Structural Compliance Certificate (Construction)

Description of Inspection: Steel Frame, Steel Trusses and Structural Steel Inspection for Proposed Building 3

Our Reference: Your Reference:	BR200435-SC-Building3-rev02				Level 7 22 Cordelia S South Brisbar	
19/09/2023					T 07 3844 590	00
					www.acor.cor	n.au
Richard Crooke Level 3, 4 Broa	s Construction P/L				ENGINEERS	
Artarmon, NSW					MANAGERS	
,					INFRASTRUC PLANNERS	CTURE
Attention: Ms Ar	ngela Wang				DEVELOPME CONSULTAN	
Dear Angela,						
STRUCTURA	ctural Certification – Build	uilig 3				
Site Details:						
Project Name.	Kingscliff Public School					
Street no. / Stree	•					
Suburb:	Kingscliff	State:	NSW	Postcod	e: 2487	
Description of	Work:		New double st	orey classroo	ms (Building 3)	
Consent:						
SSD No. SSD-8378620-MOD-1		Consent auth	nority:	N/A		
			Dated:		15 June 2023

SITE INSPECTION REPORT

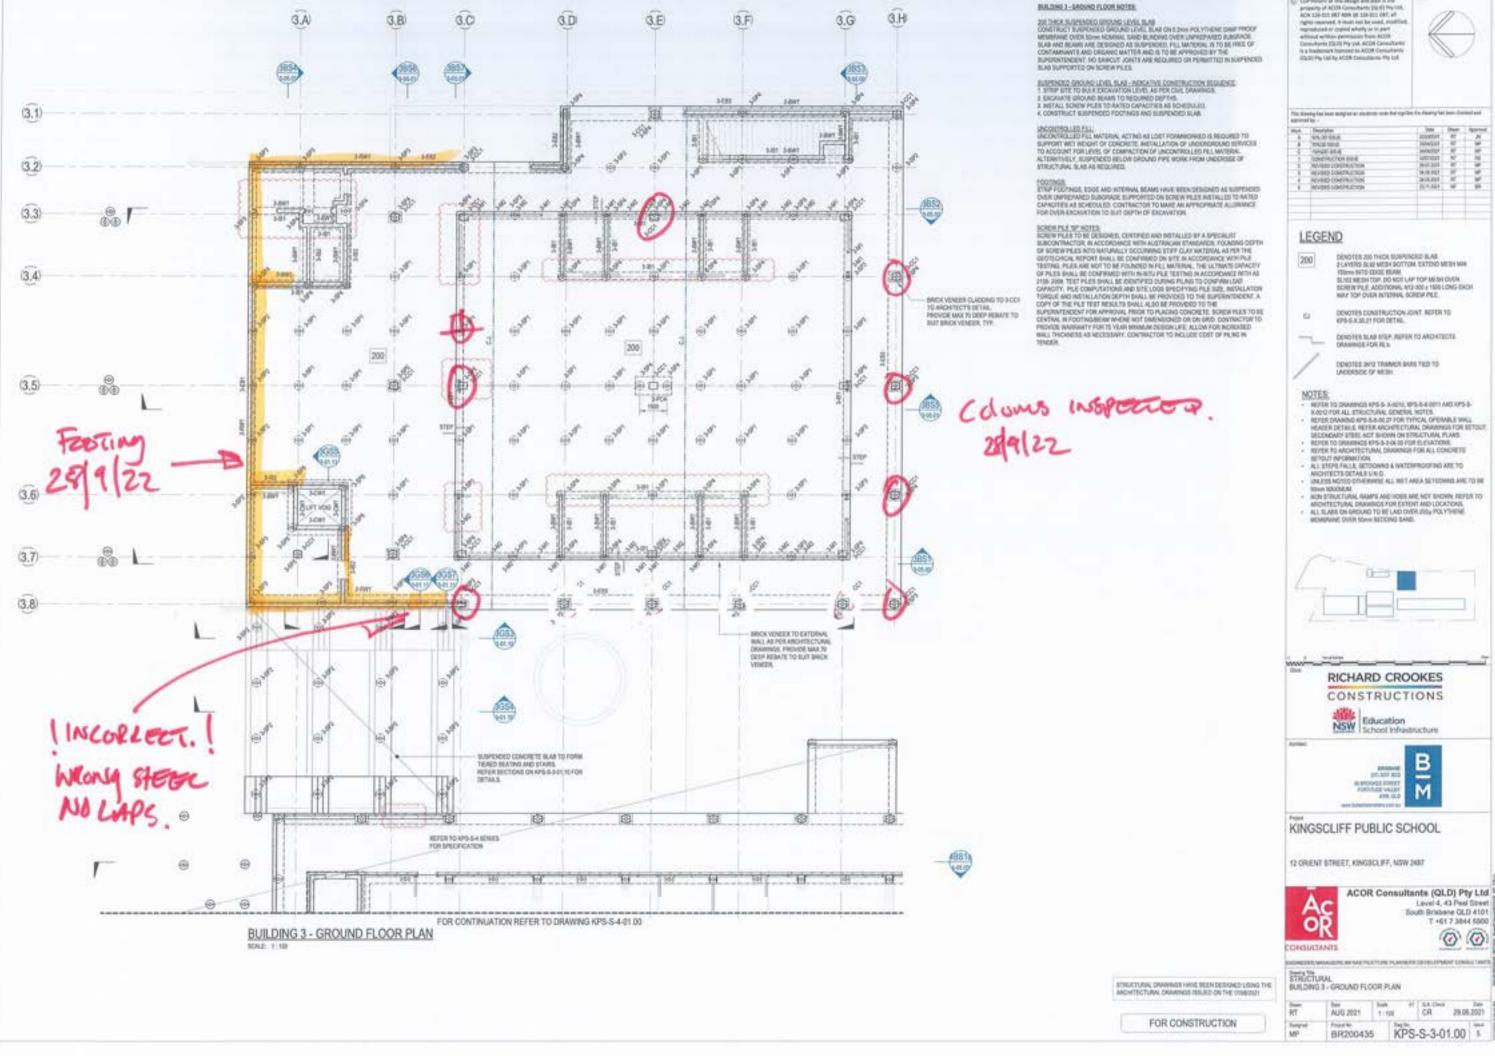
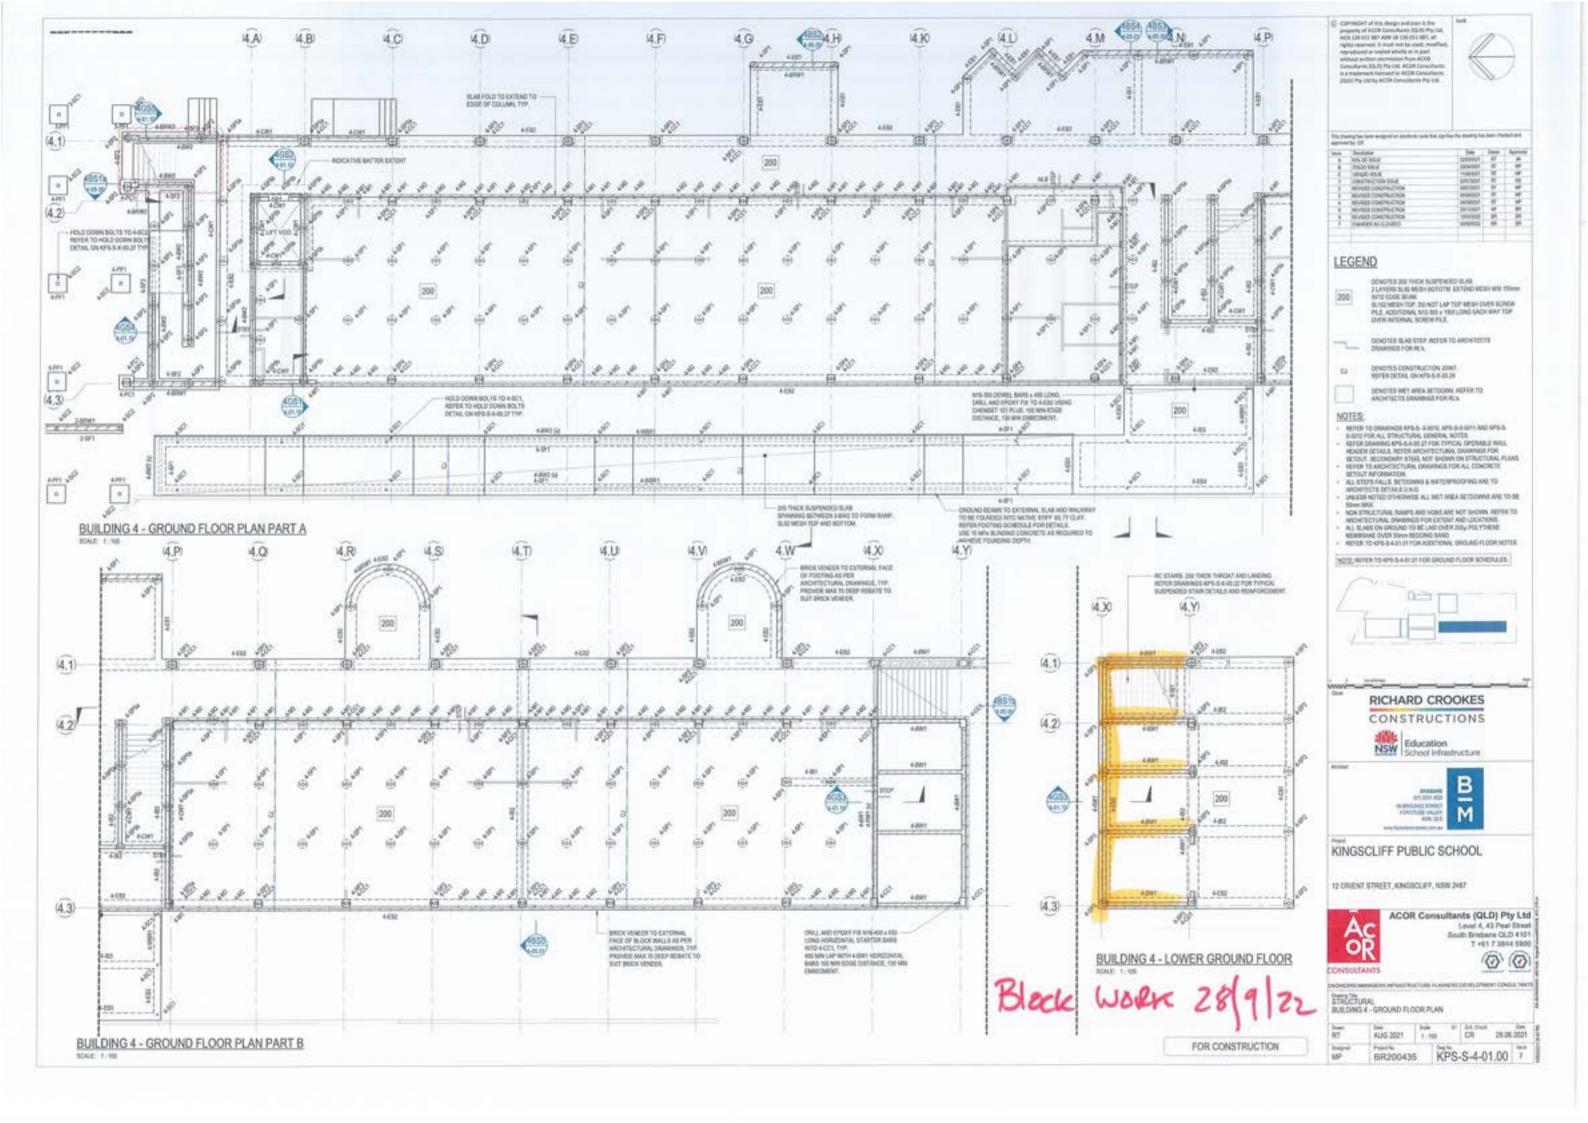
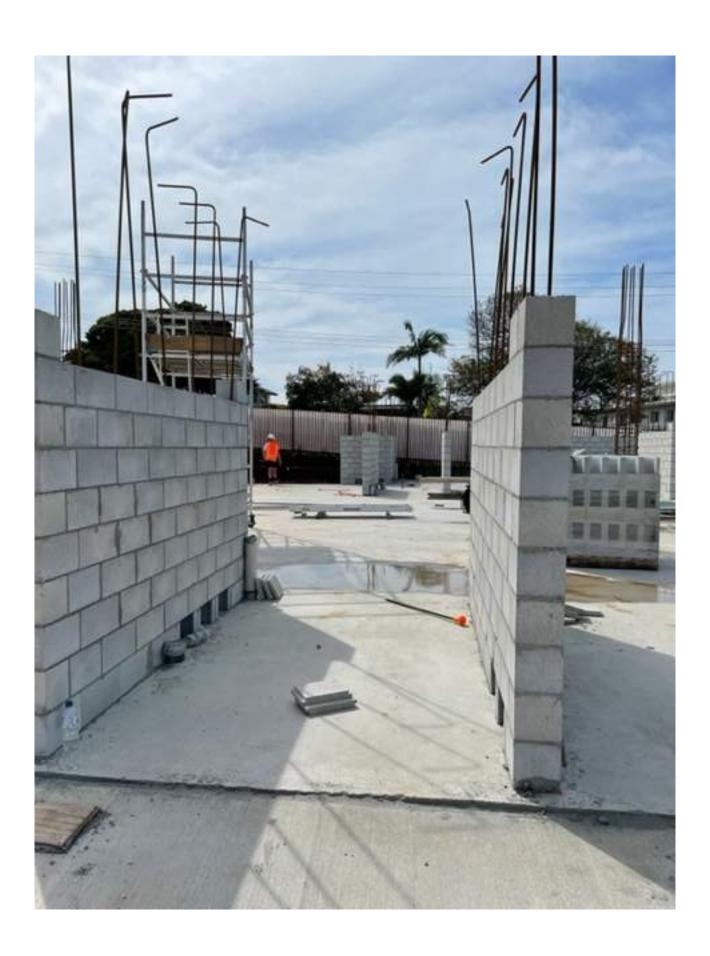
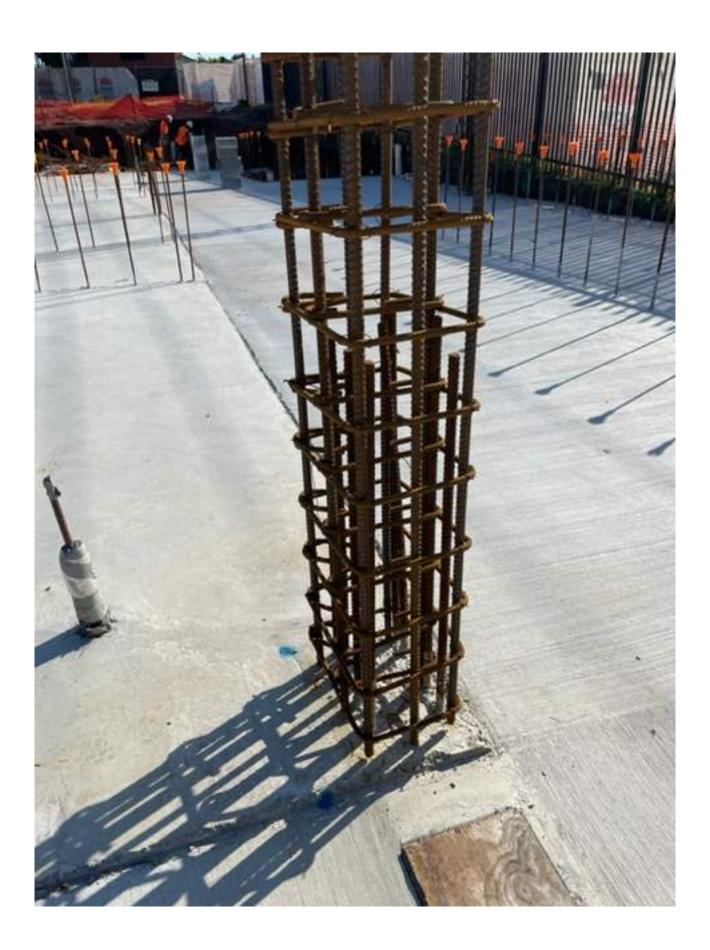
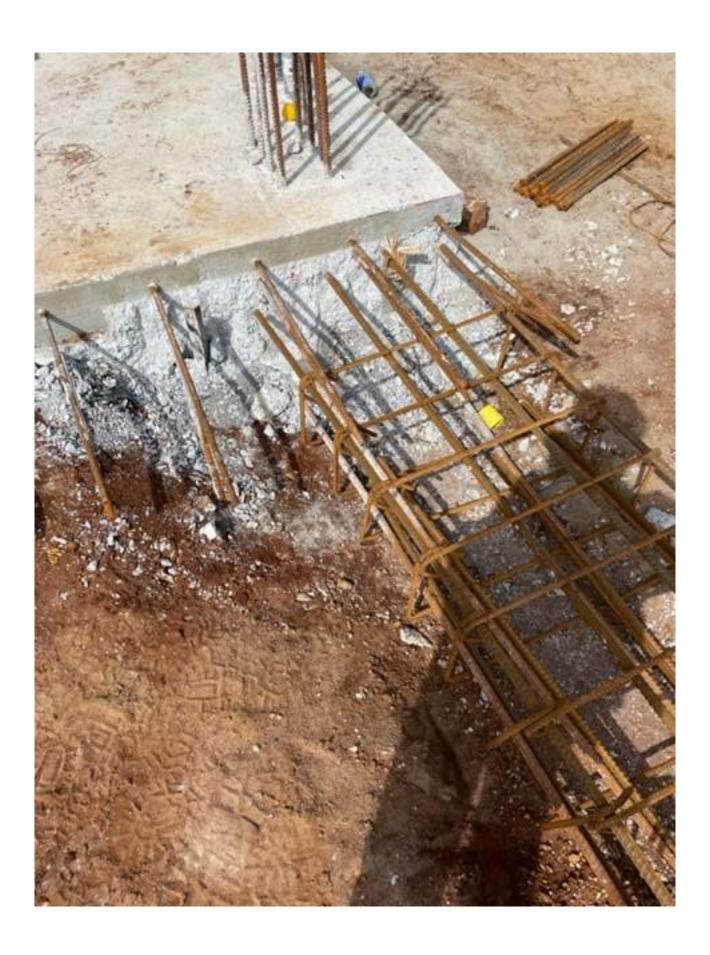
1. * Bu	MIDING 4 - PLACE AU RETAINING NALL VERTICALS
2. ON	CORRECT FACE
	THEN OK TO POUR
4. X B	ulping 3 - Bloak ways 1.8 HT -
5	ok to Poul.
6. * B	ullding 3 Colomns
7. — 2	ENSURED CORRECT COVER WHEN BOXED
	THEN OK TO POUR.
9. * 7	ZOUNGS - INCORRECT - POUR STOPPED
10. R	EFER CORRESPONDENCE WITH ACOR.
11.

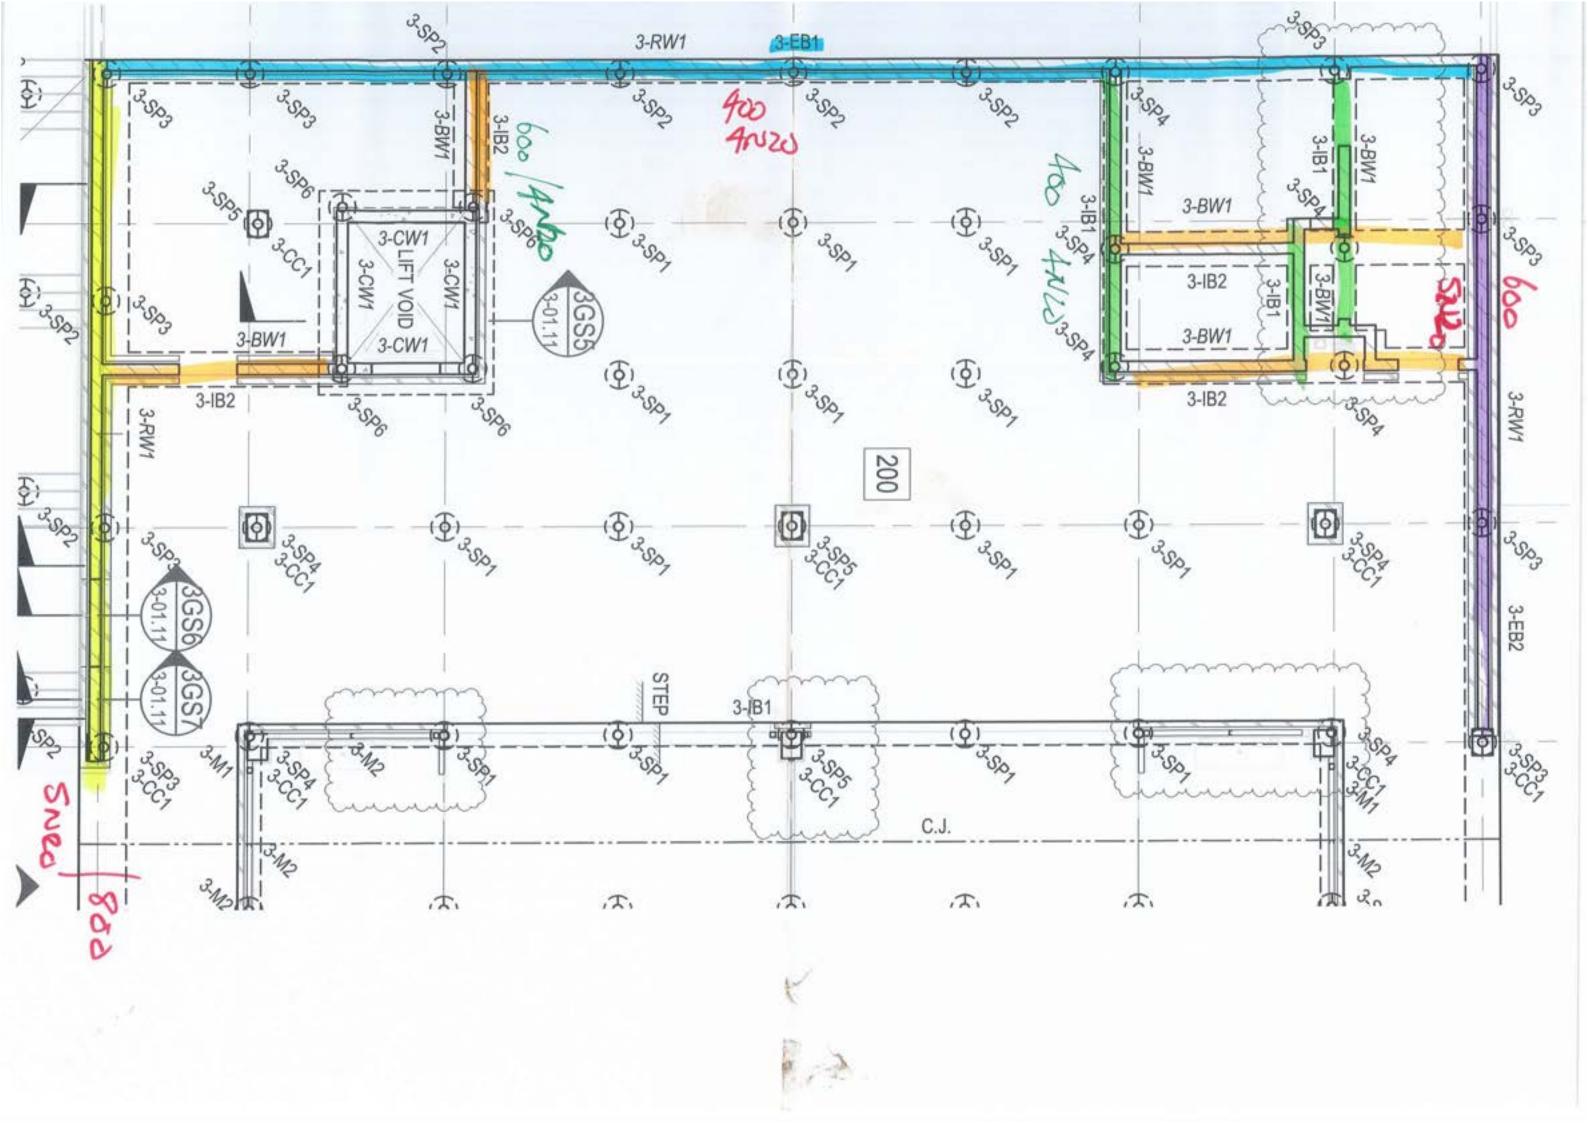
1. *	RE-INSPECTION OF BLAKDING 3 FEDTINGS
2.	EXTENT RETER MARKEUP.
3.	- Company of the comp
	GLEAN & REMOVE DEBRIS FROM
5-	Footings
6.	
7. 🟋	CLEATE COLLECT COVER FOR LIFT WALL.
8,	1:11=1 12 1 1 = 1
9-	WHEN ABOVE COMPLETS OR to FOUR.
10.	
11.

STRUCTURAL BUILDING 2 - GROUND FLOOR PLAN

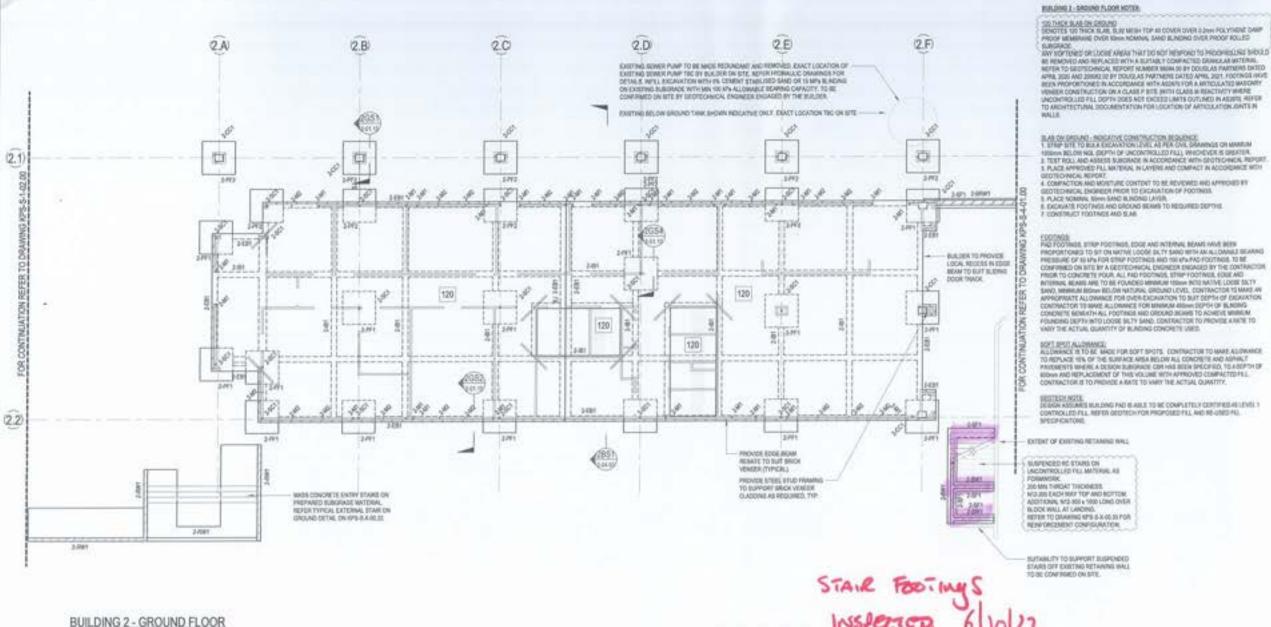
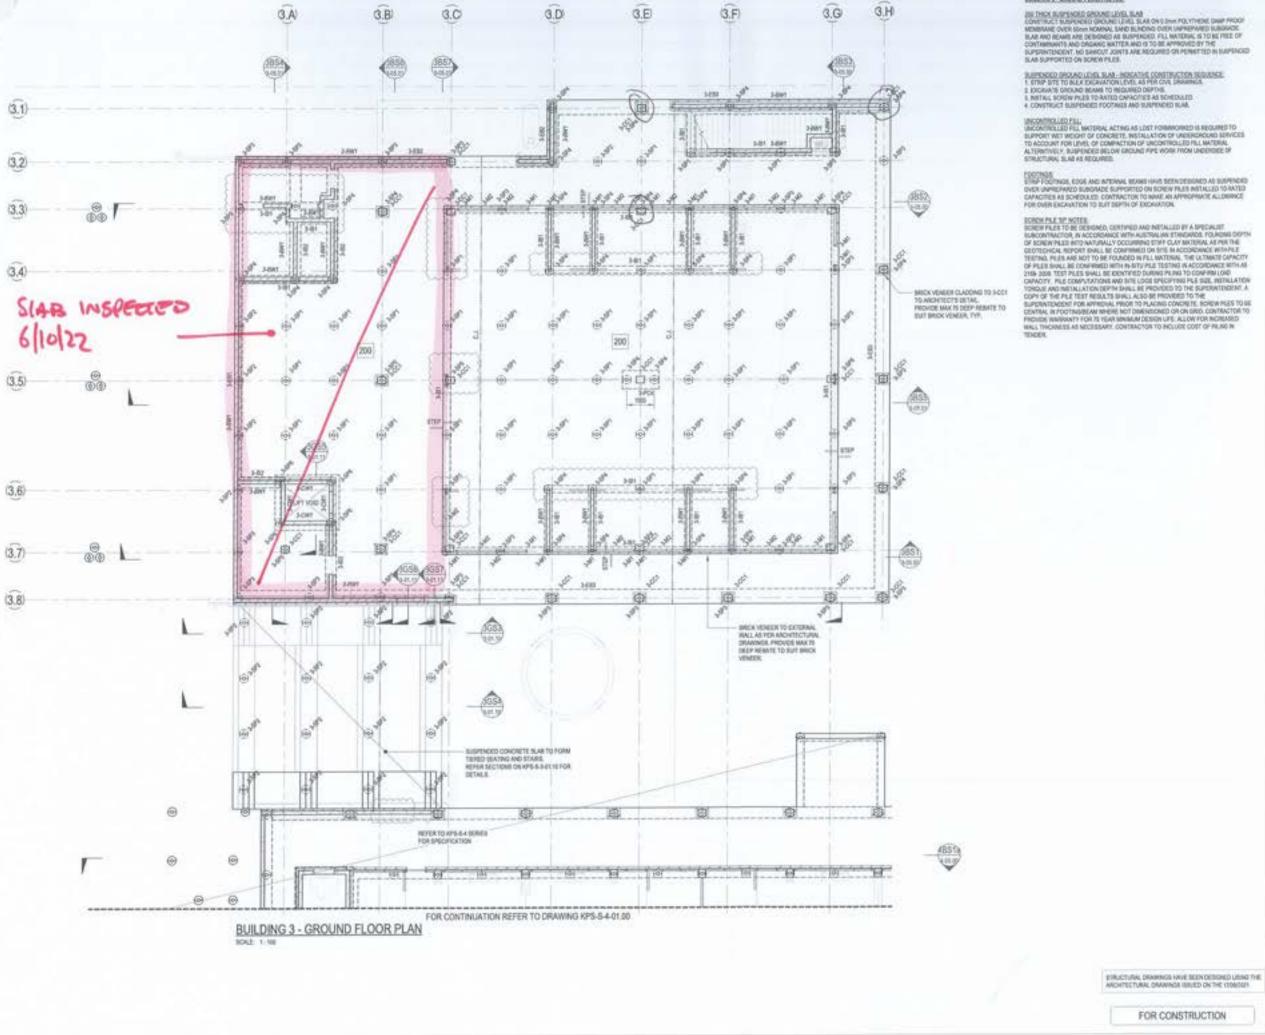
1. EXTENT OF INSPECTIONS - REFER
2. AT TACHED MARK-UP.
Buil Ding 3
4 X ENSURG 2 X N/2 CRANKED U' BARS OUTER
5. SCREW PILES - AS PER DRAWING
6. WHEN ABOVE COMPLETED OUTS POUR
Buldwy 2
8'ADD EXTRAZNE TOP/BOT OF
9. FOSTINGS + Z' STEP BARS.
10. ADD CORNER BARS AS PER
11. Steduce.
